# Access Compliance Report

## Public Rights-of-Way

Intersection ID: 31730	Main Street: RAISIN_TREE_LN	Cross Street: LEAF_PLUM_DR	Location: SW
ADA ID: BCC14495140E	Ramp Type: PerpDiag	Initial Pass/Fail: Fail	Overall Compliance: No
Severity Score: 8.75			
Codes/Mitigation Info/Possible Solution		Field Measurements/Component Compliance

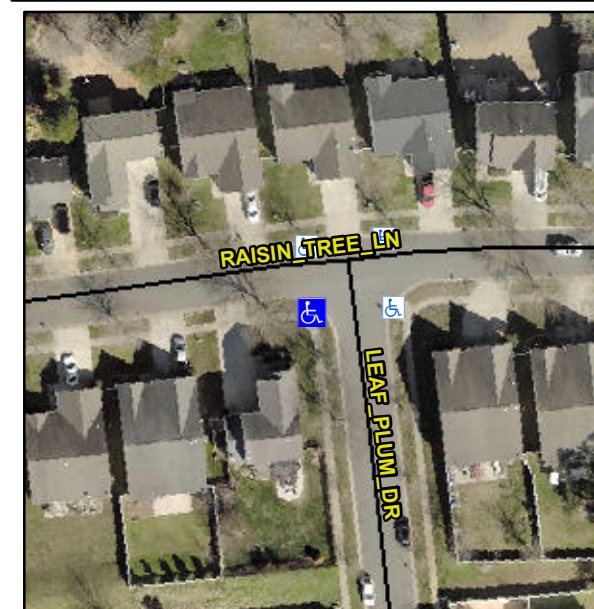
**Not Found, R304.5.1**

Compliance	Description	Data	Compliance	Description	Data
N/A	Ramp Length (in)	83.0	Yes	Ramp Slope (%)	7.3
No	Ramp Width (in)	47.0	Yes	Ramp XSlope (%)	0.0
N/A	Flare Type LT	N/A	N/A	Flare Type RT	N/A
N/A	Flare Slope LT (%)	N/A	N/A	Flare Slope RT (%)	N/A
N/A	Flare Traversable LT?	N/A	N/A	Flare Traversable RT?	N/A
N/A	Landing Length (in)	N/A	N/A	DWS Provided?	N/A
N/A	Landing Width (in)	N/A	N/A	DWS Contrast?	N/A
N/A	Landing Slope (%)	N/A	N/A	DWS Length (in)	N/A
N/A	Landing X Slope (%)	N/A	N/A	DWS Full Width?	N/A
N/A	Landing Curb? (Y/N)	N/A	N/A	DWS Offset (in)	N/A
N/A	Shared Landing?	N/A			
N/A	Gutter Ponding?	Yes	N/A	Gutter Slope (%)	N/A
N/A	Gutter Lip Ht (in)	N/A	N/A	Gutter X Slope (%)	N/A
N/A	Painted X Walk1?	No	N/A	Painted X Walk2?	No
	X Walk 1 Direction	To E		X Walk 2 Direction	To N
N/A	X Walk 1 Width (in)	N/A	N/A	X Walk 2 Width (in)	N/A
	X Walk 1 Slope (%)	5.3		X Walk 2 Slope (%)	4.6
	X Walk 1 X Slope (%)	0.3		X Walk 2 X Slope (%)	2.8

**Remove & Replace Curb Ramp With Two New Directional Ramps or Equivalent.**
